ADDENDUM NO. 2

TO: PLANS AND SPECIFICATIONS FOR STATE OF MISSOURI

**Renovate Interior
General Headquarters Complex
Jefferson City, MO
PROJECT No.: R2410-01**

P-104

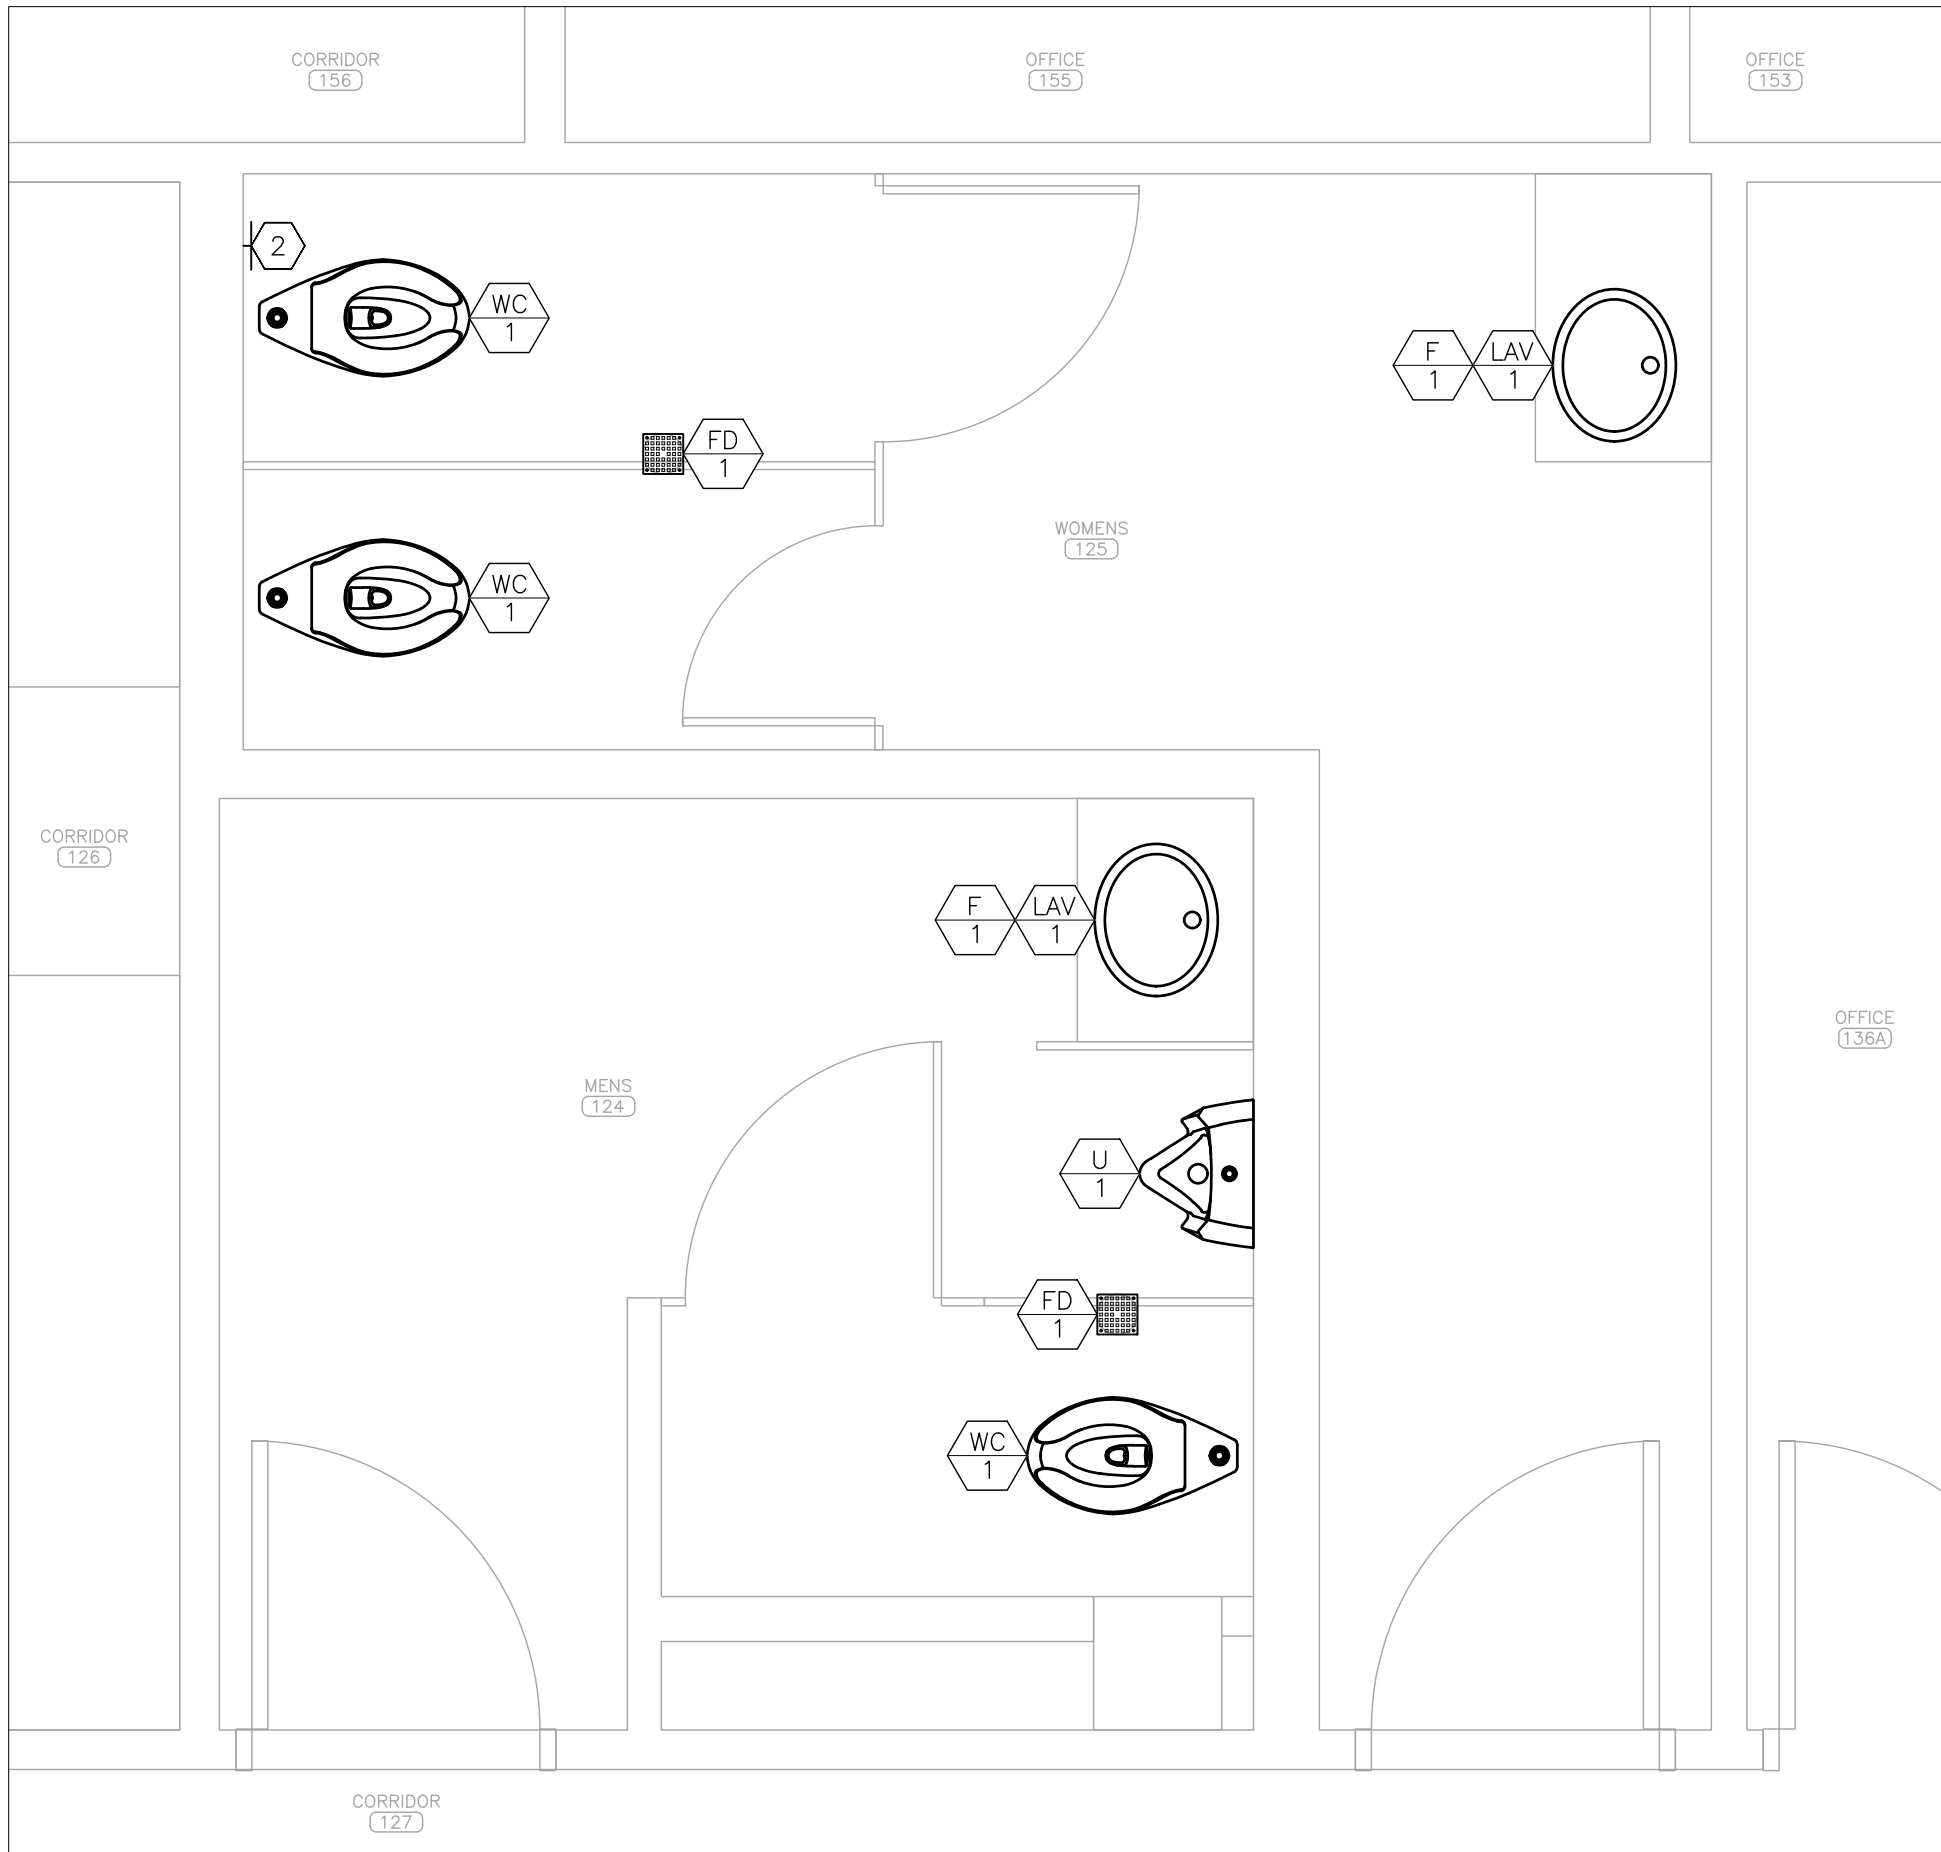
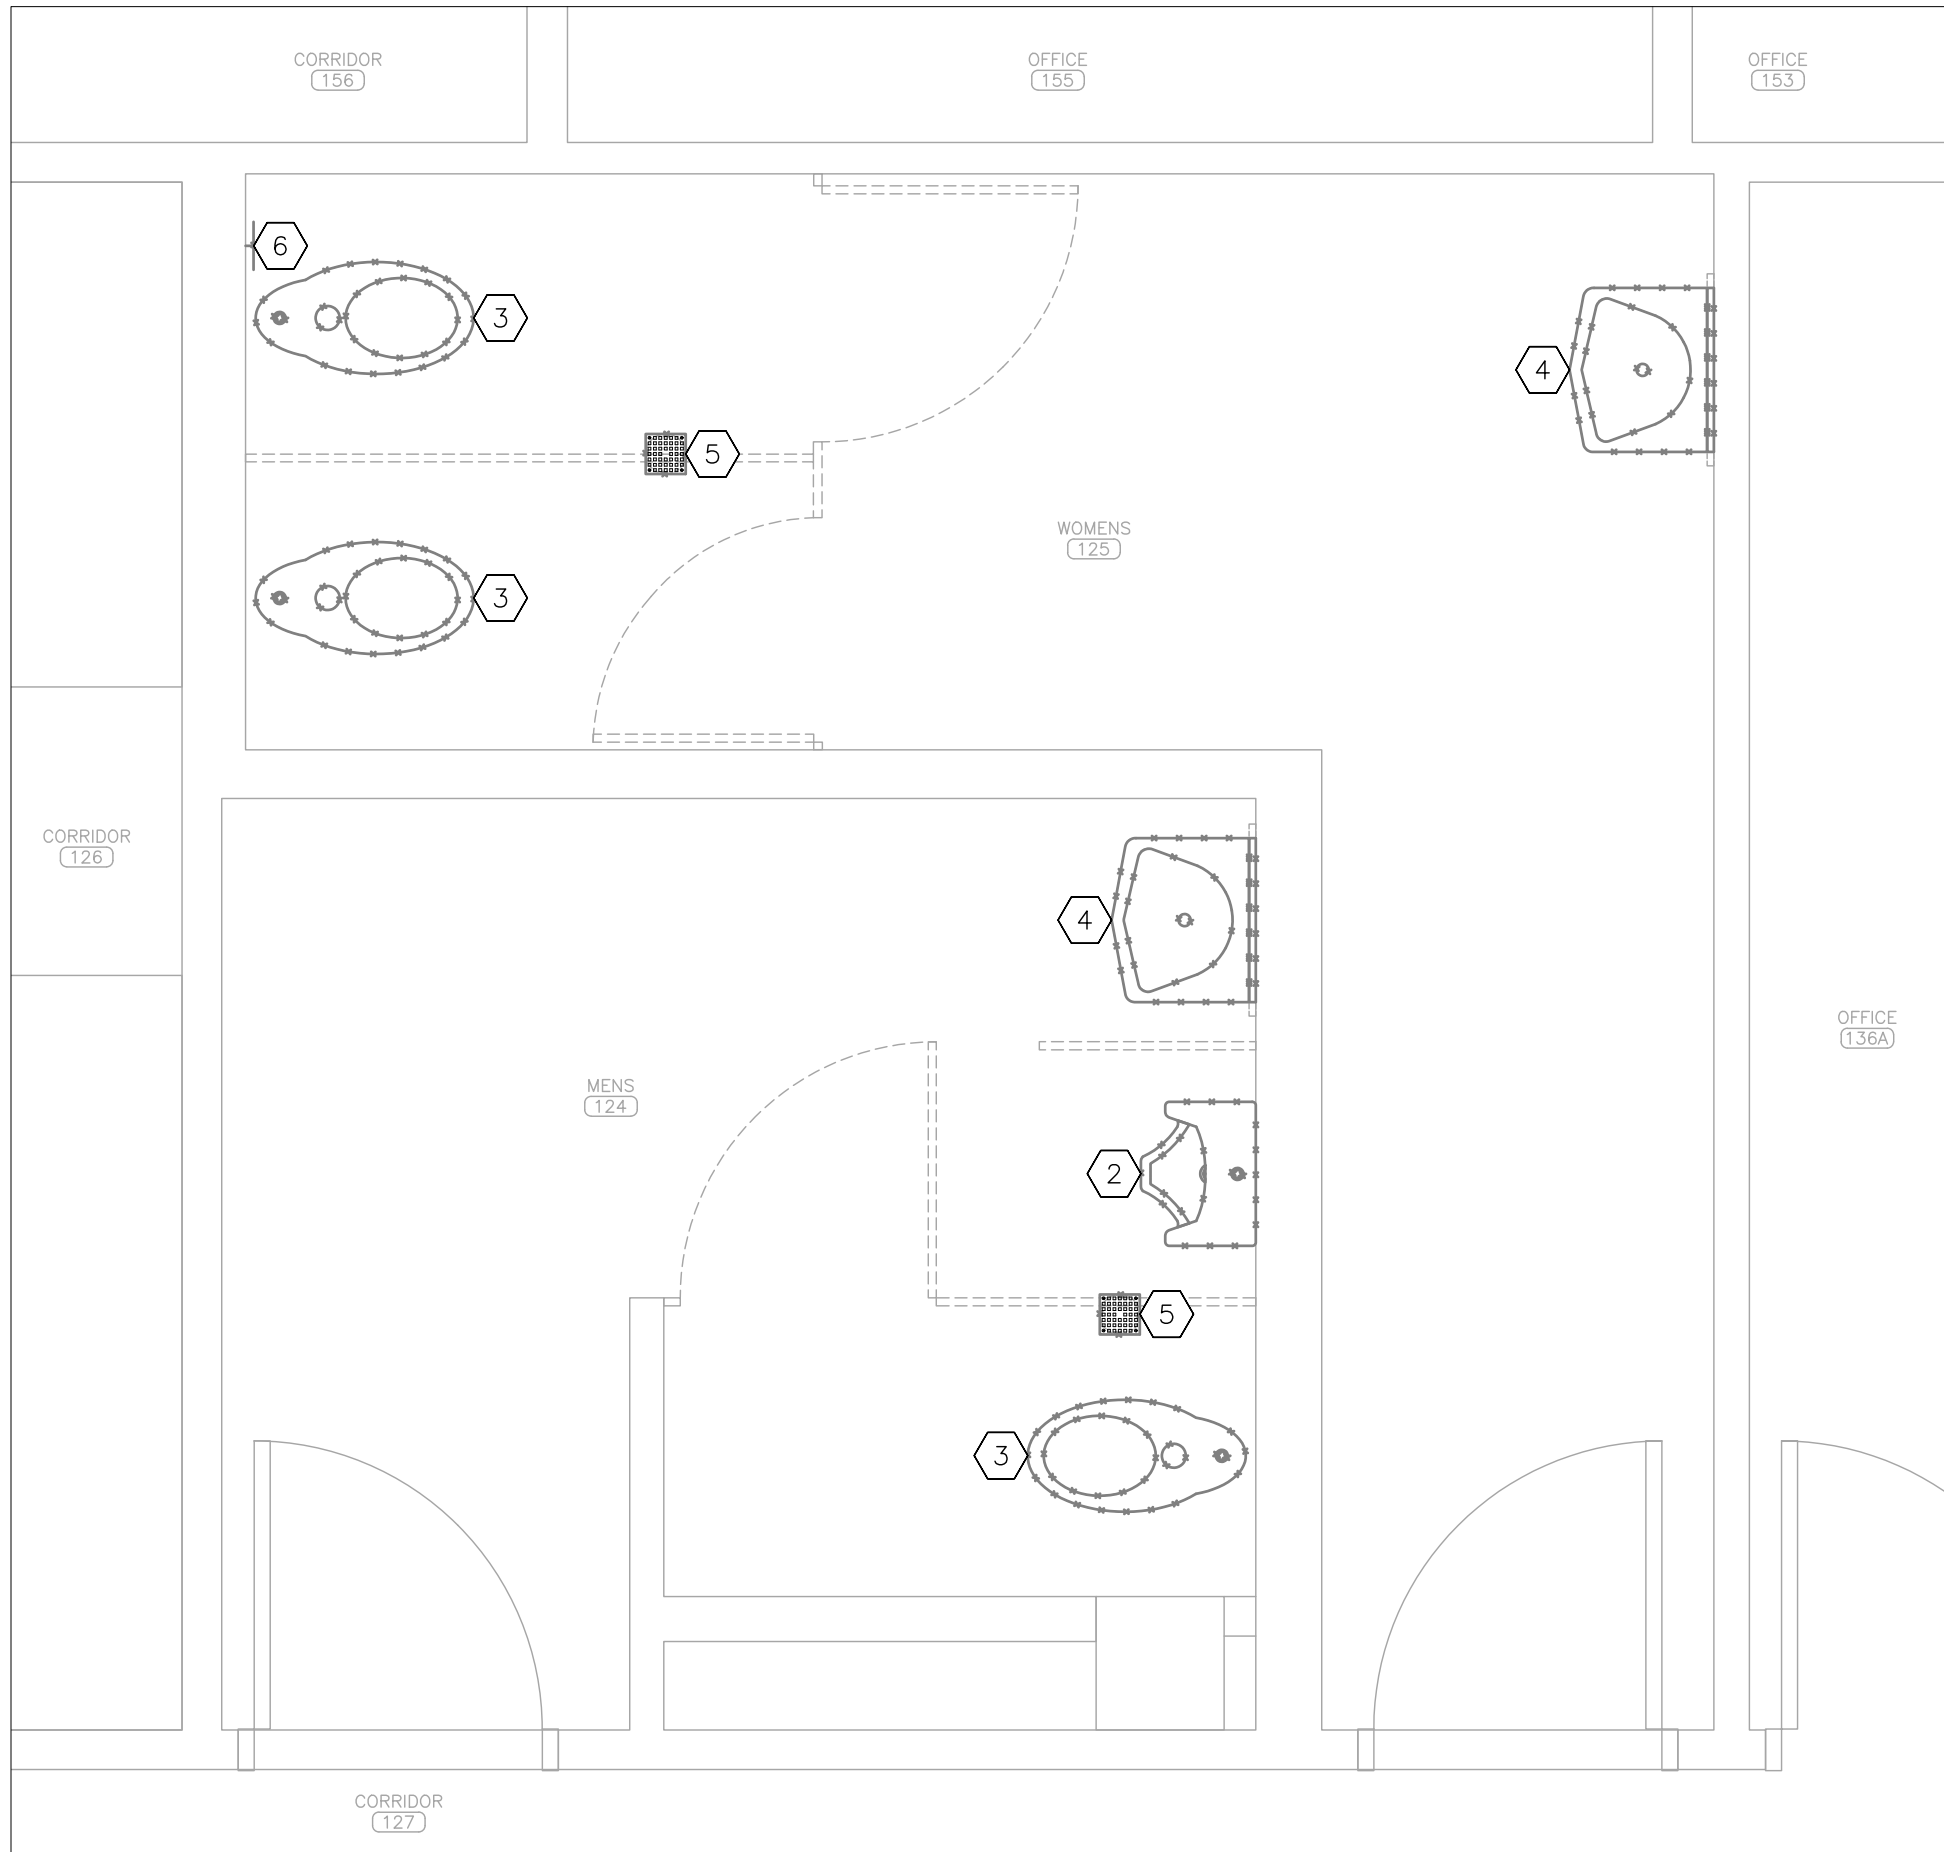
1. P-101: Add Demolition Keynote 10.
2. P-104: Add Demolition Keynote 7.

- 1 REFER TO SHEET P-101 FOR GENERAL DEMOLITION NOTES.
- 2 DEMOLISH URINAL AND ASSOCIATED FLUSHOMETER. WATER SUPPLY AND SANITARY DRAIN LOCATIONS TO REMAIN.
- 3 DEMOLISH WATER CLOSET AND ASSOCIATED FLUSHOMETER. WATER SUPPLY AND SANITARY DRAIN LOCATIONS TO REMAIN.
- 4 DEMOLISH LAVATORY, FAUCET, RISERS, AND SUPPLY STOPS. HOT AND COLD WATER SUPPLY AND SANITARY DRAIN LOCATIONS TO REMAIN.
- 5 DEMOLISH FLOOR DRAIN STRAINER. ASSOCIATED SANITARY DRAIN BODY AND PIPE TO REMAIN.
- 6 DEMOLISH WALL CLEANOUT COVER. ASSOCIATED SANITARY CLEANOUT AND DRAIN PIPE TO REMAIN.
- 7 LABEL PLUMBING PIPE FITTINGS AS CONTAINING ASBESTOS.
